ARCHITECT'S SUPPLEMENTAL INSTRUCTIONS

Date Issued:	March 5, 2020
Project:	Intermountain Healthcare Tooele Valley Dialysis Clinic Expansion 2356 North 400 East, Suite #102 Tooele, Utah 84074
Architect's Supplemental Instructions:	ASI #1
To:	Saunders Construction 1113 South 500 West Bountiful, Utah 84010

RE: ASI-001 – Department of Health Requests

Electrical ASI #01

G111

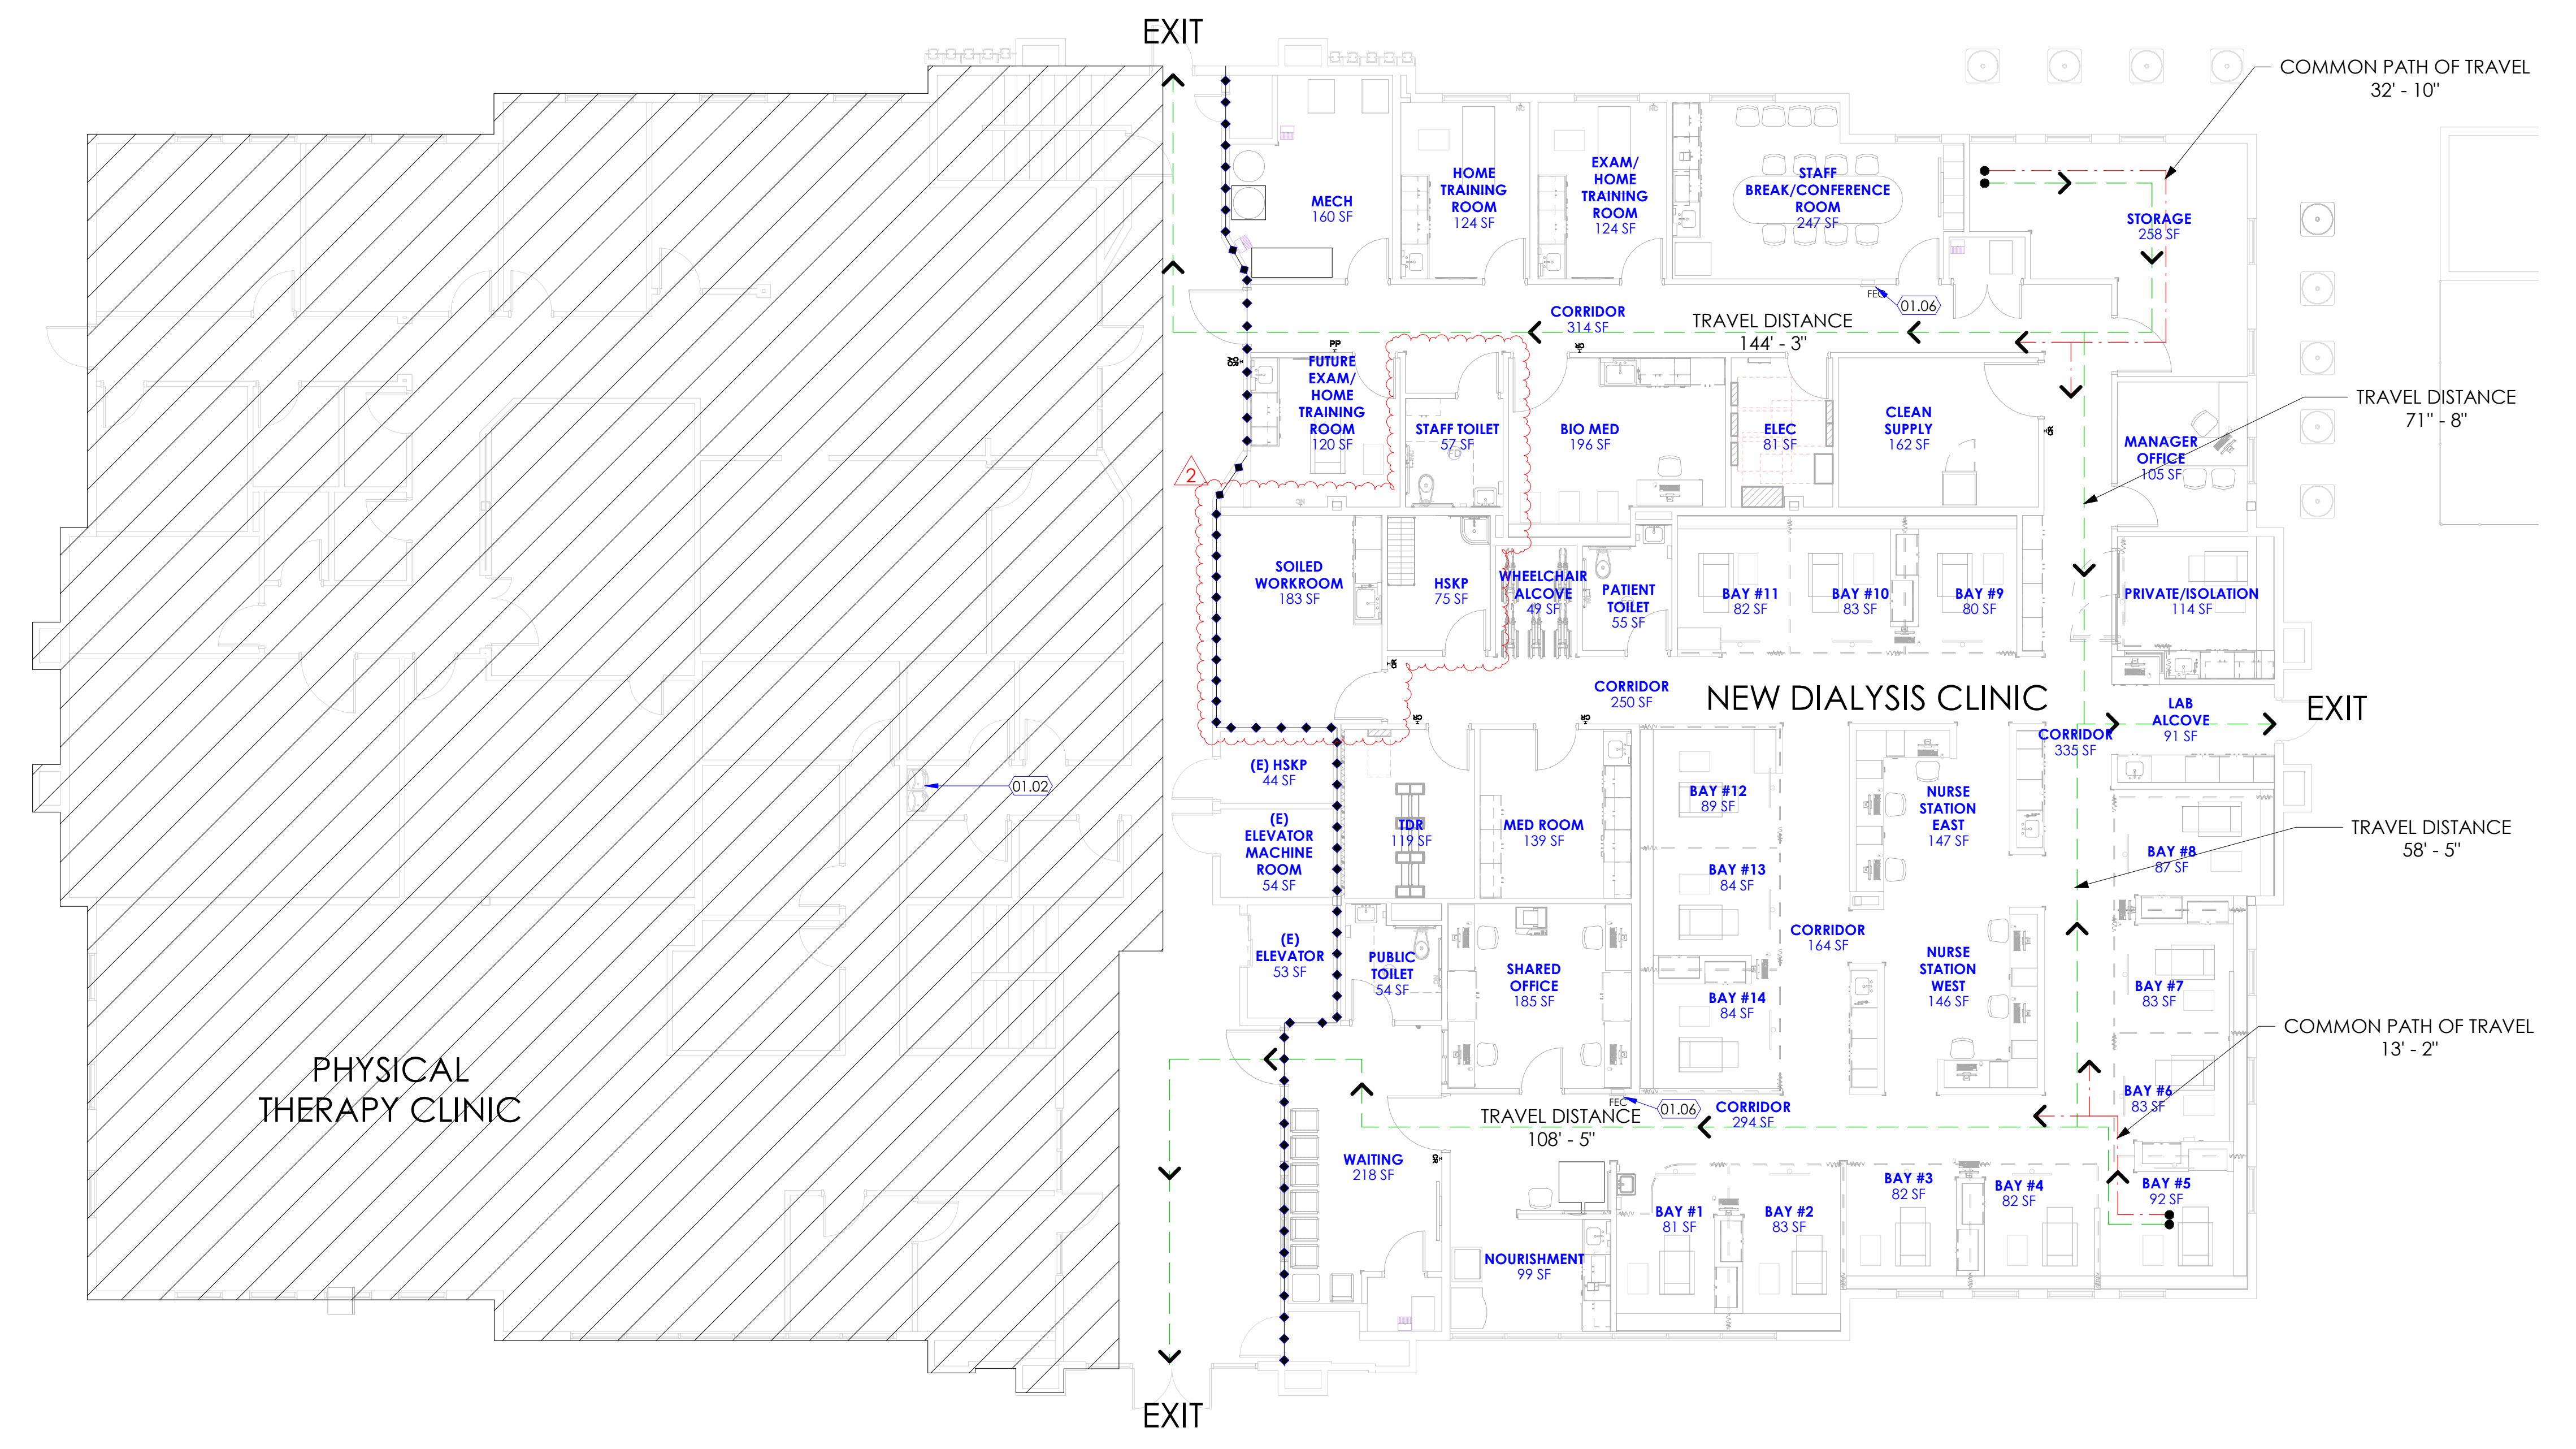
6	<u>Sheet G111, A115, A116, A117, A251, A252, A601A</u> - See attached Revised sheets with revisions shown clouded for more information.
7	See attached Mechanical & Plumbing ASI #1 from VBFA Engineers.
8	See attached Electrical ASI #1 from Spectrum Engineers.

MH101

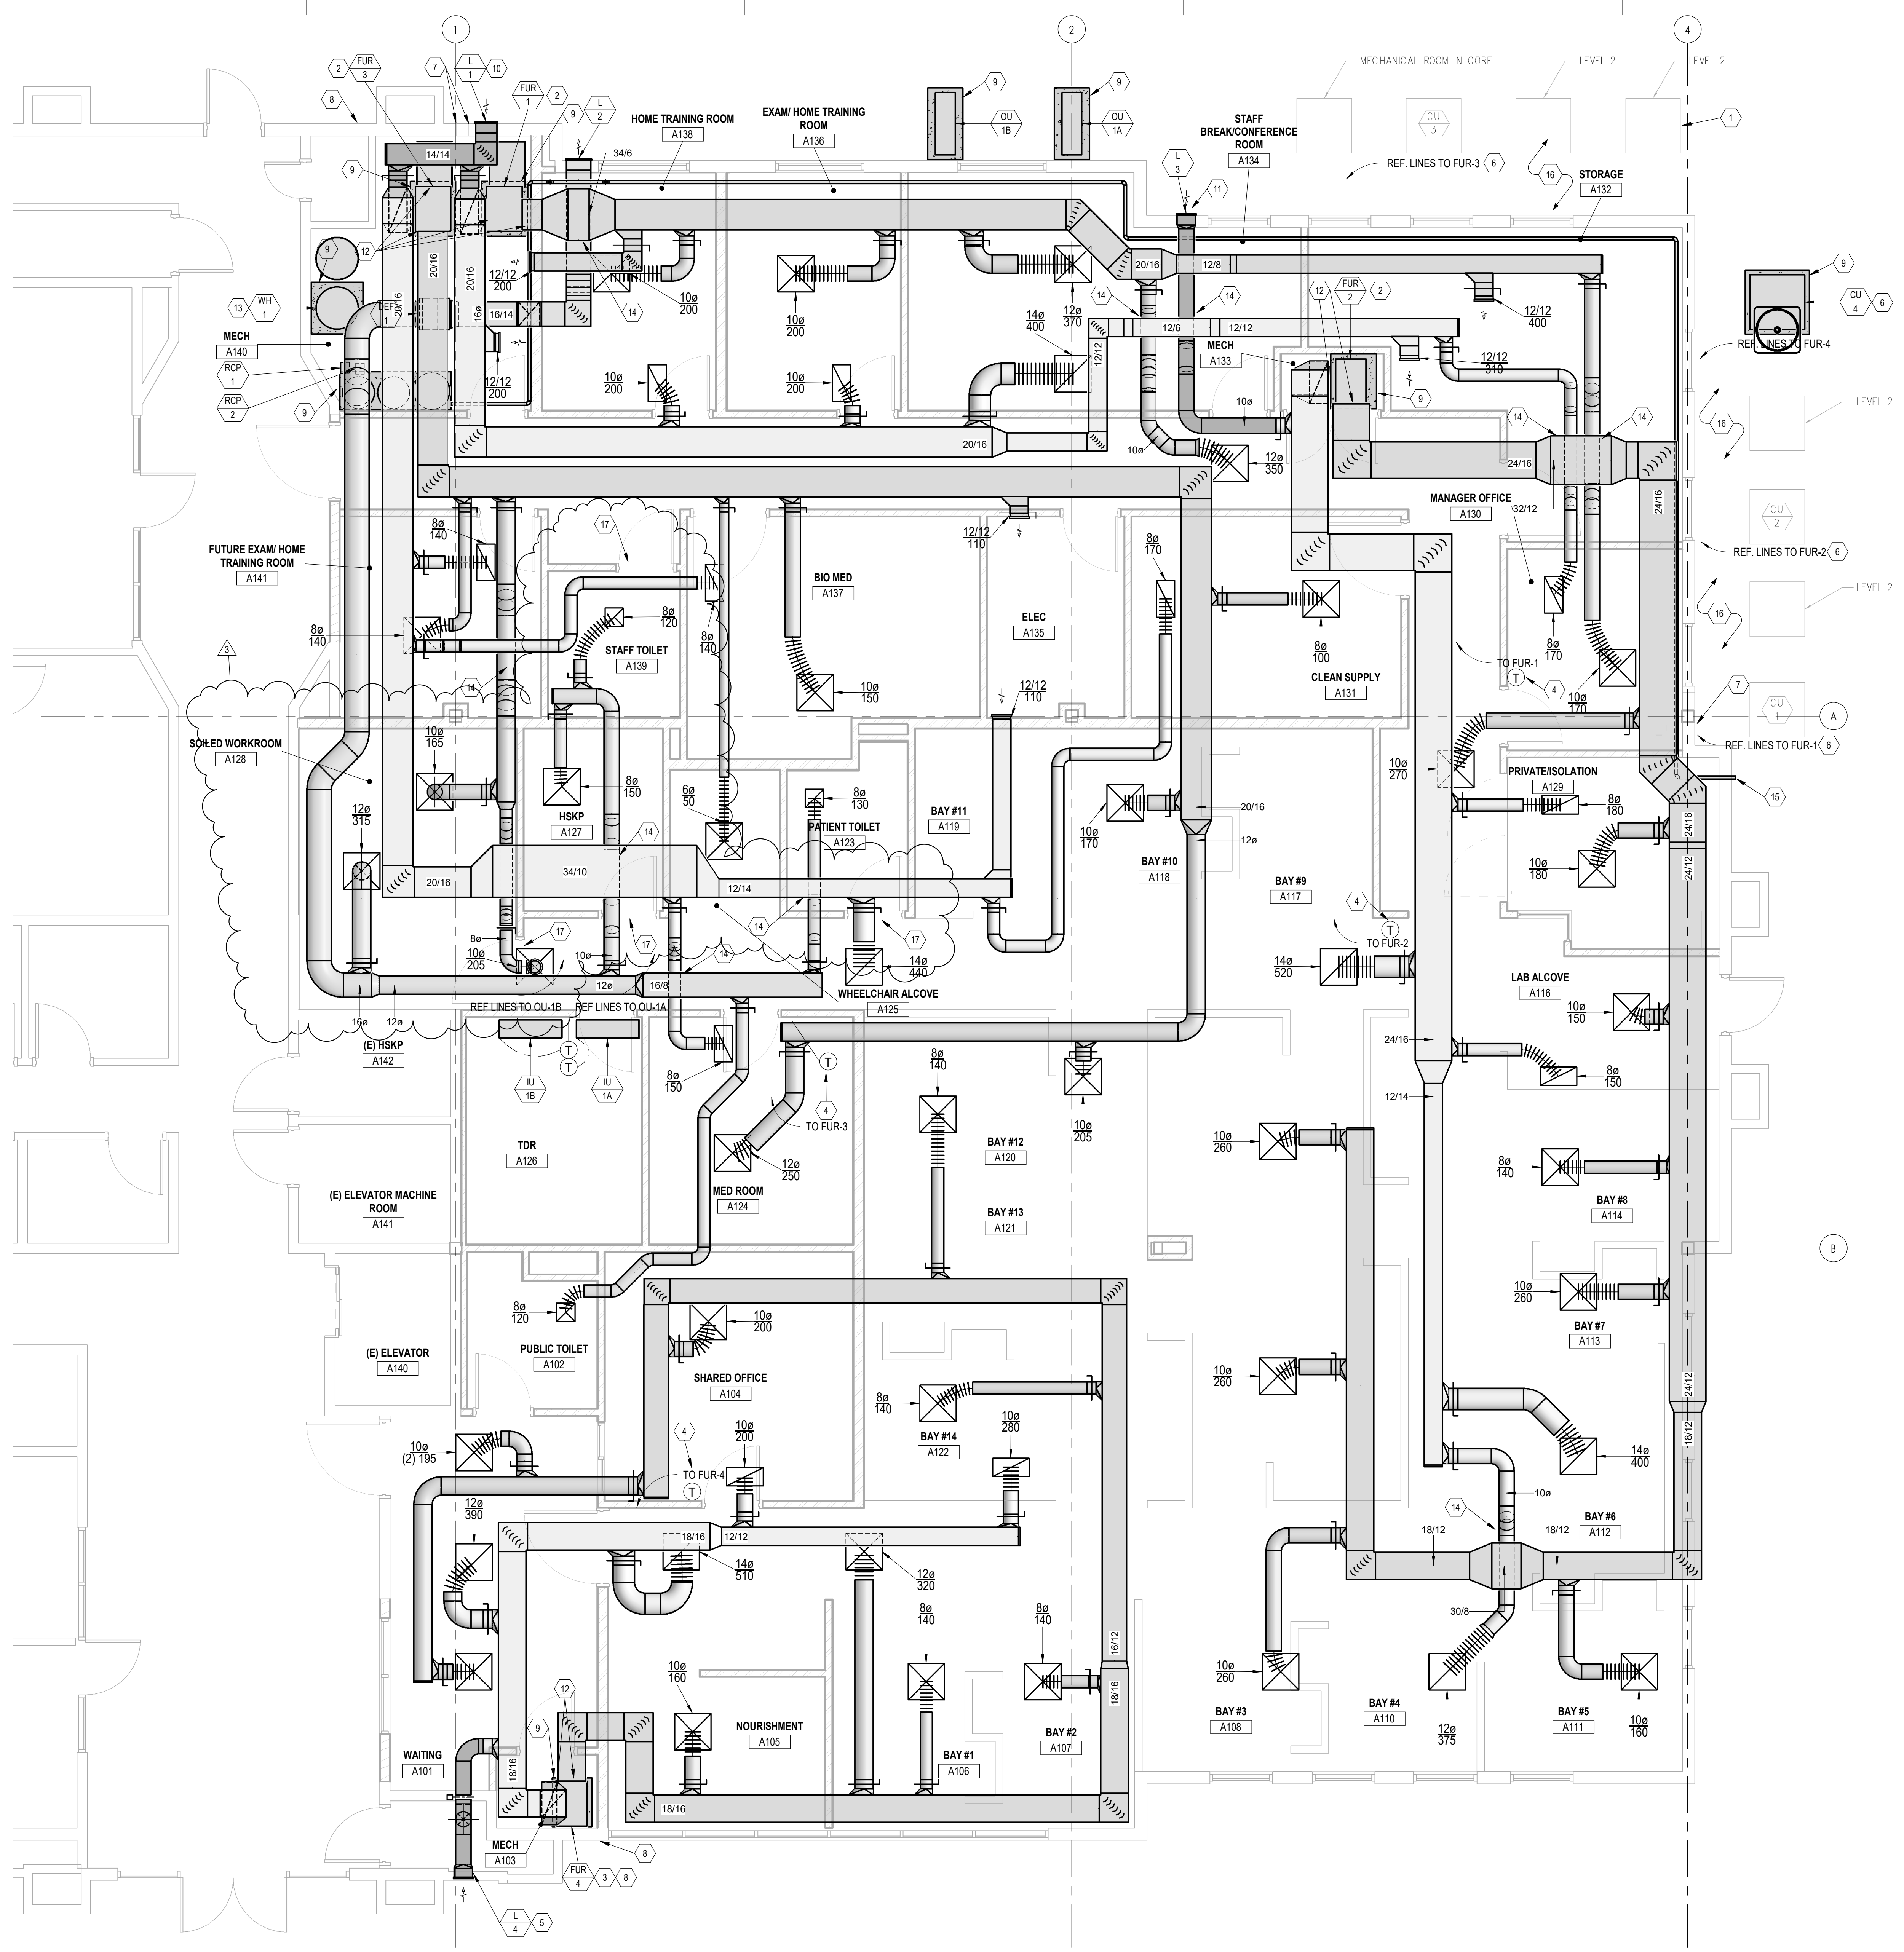
1. Exhaust and supply airflows adjusted for Soiled Workroom (A123), Staff Toilet (A129), and HSP (A127).
2. Keyed Note 17 added to drawings.

PP100

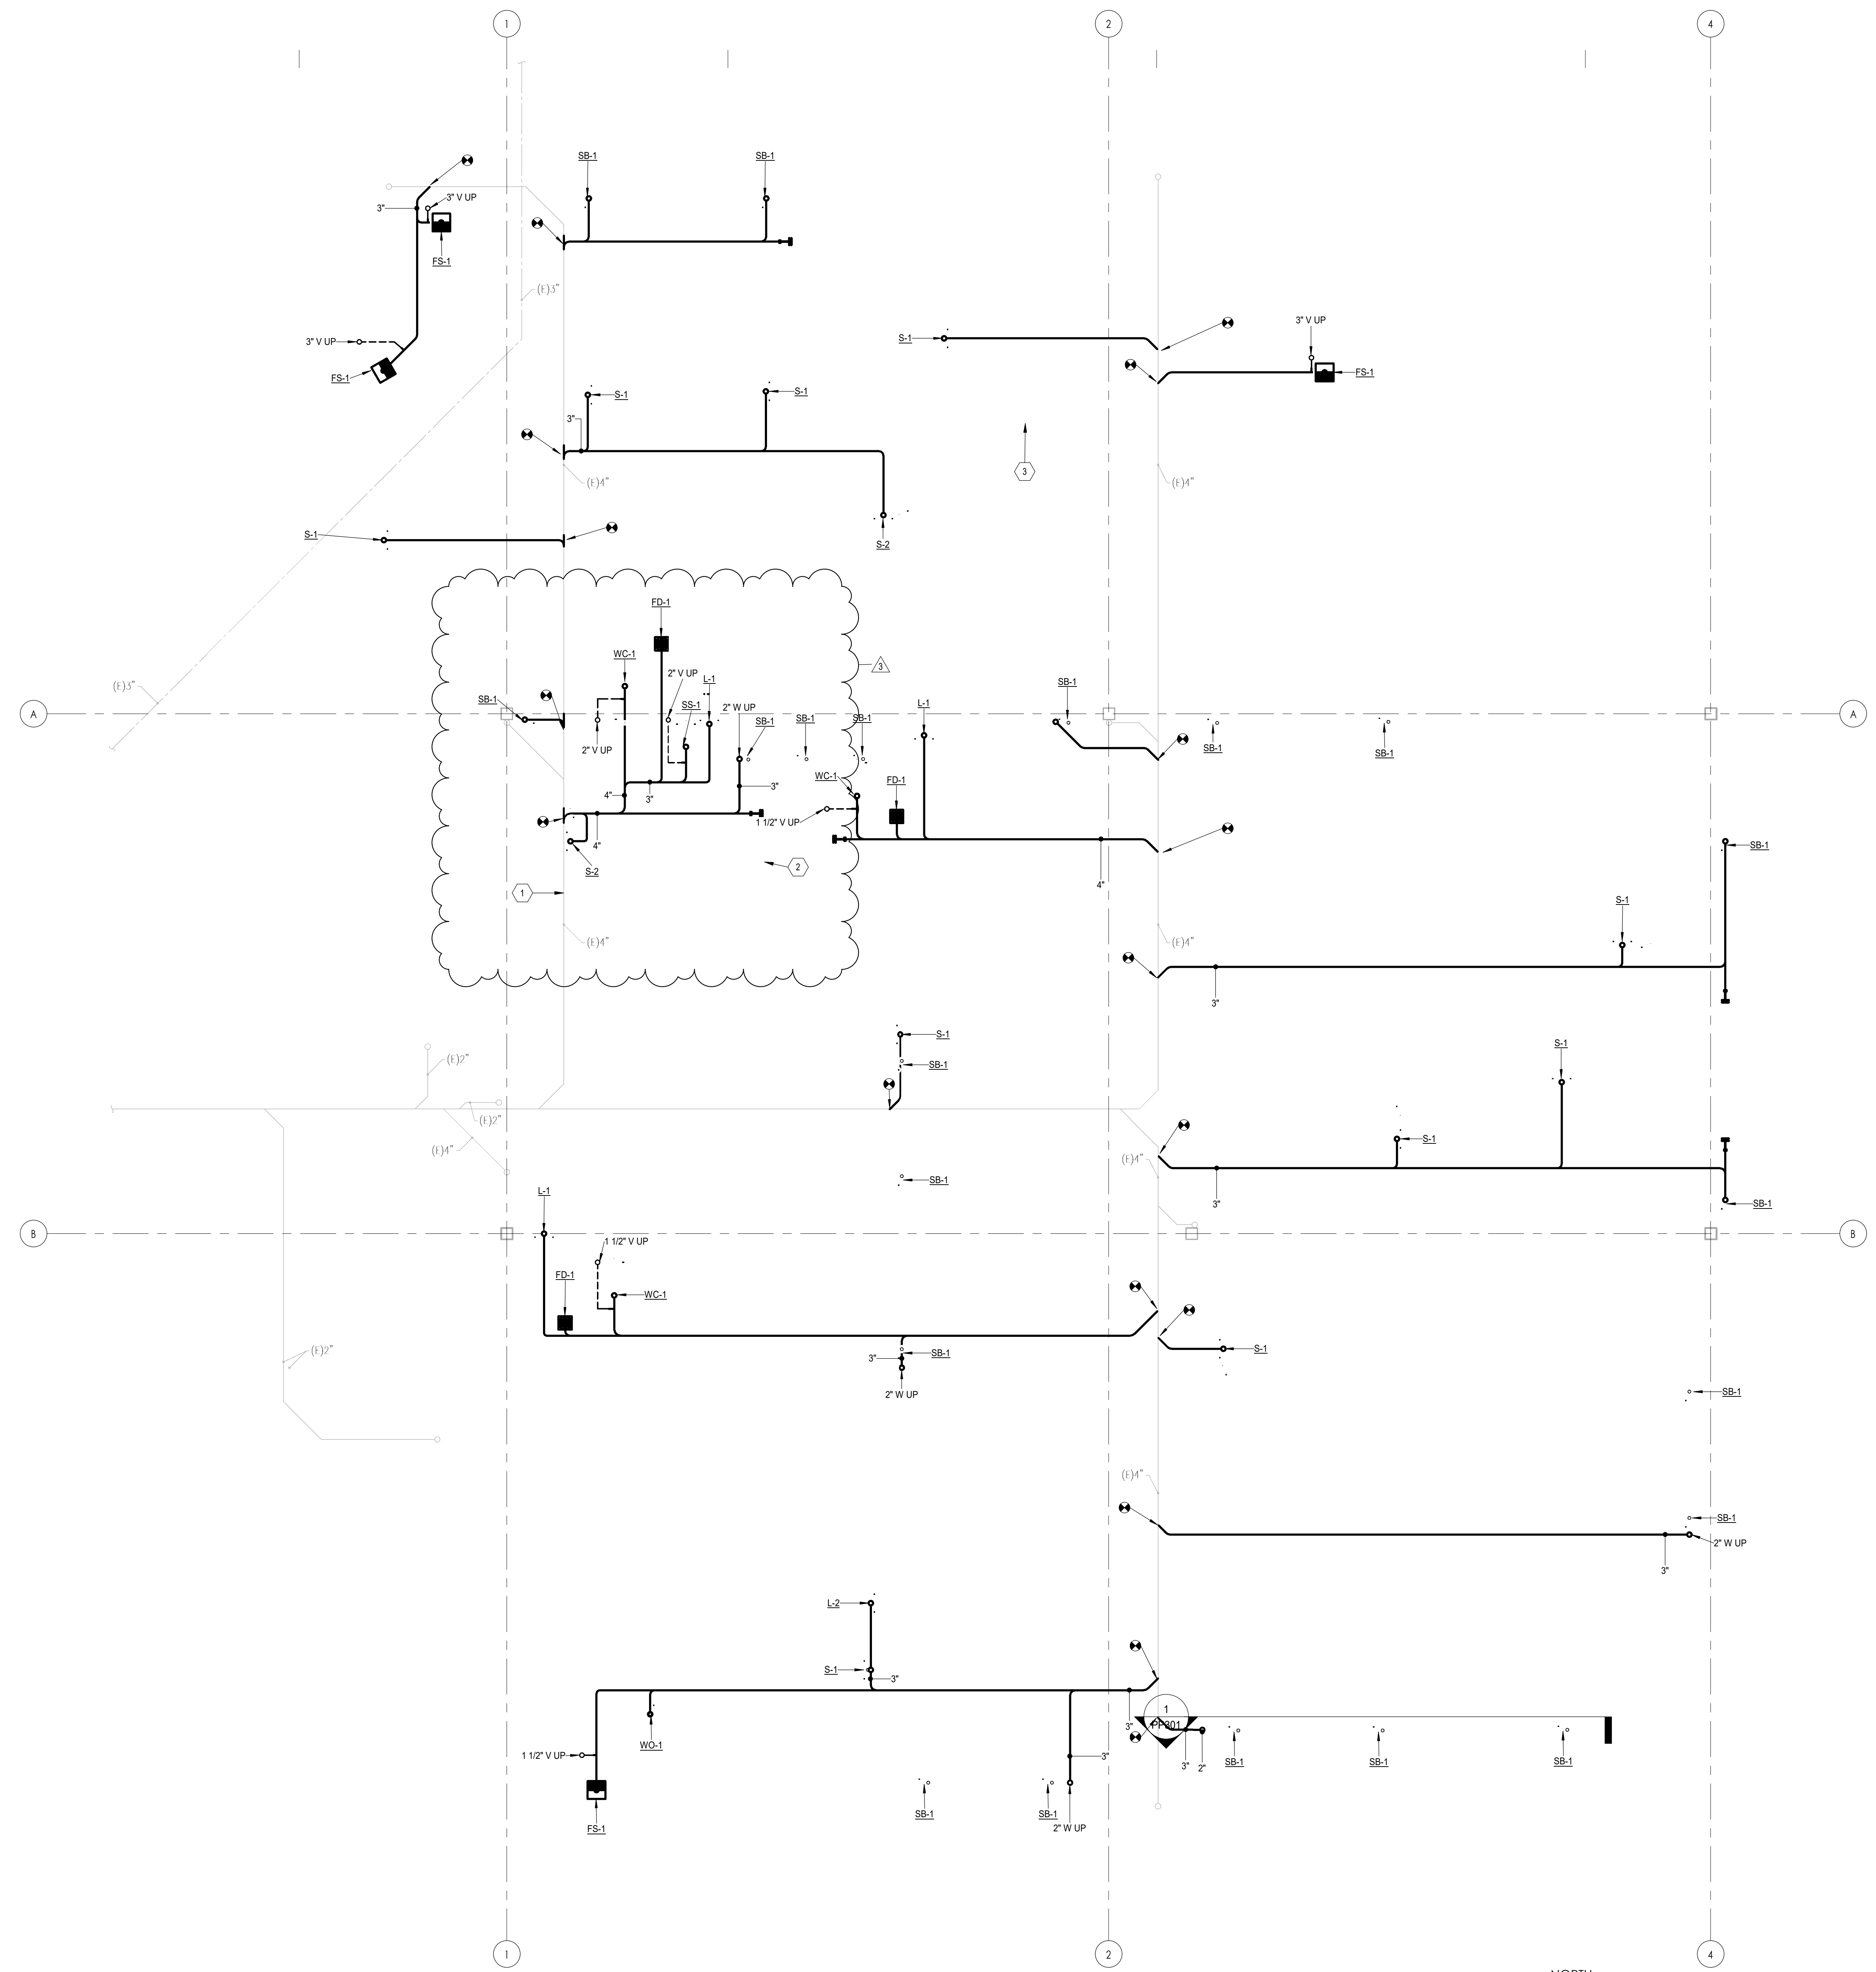
1. Plumbing updated to match relocated fixtures.
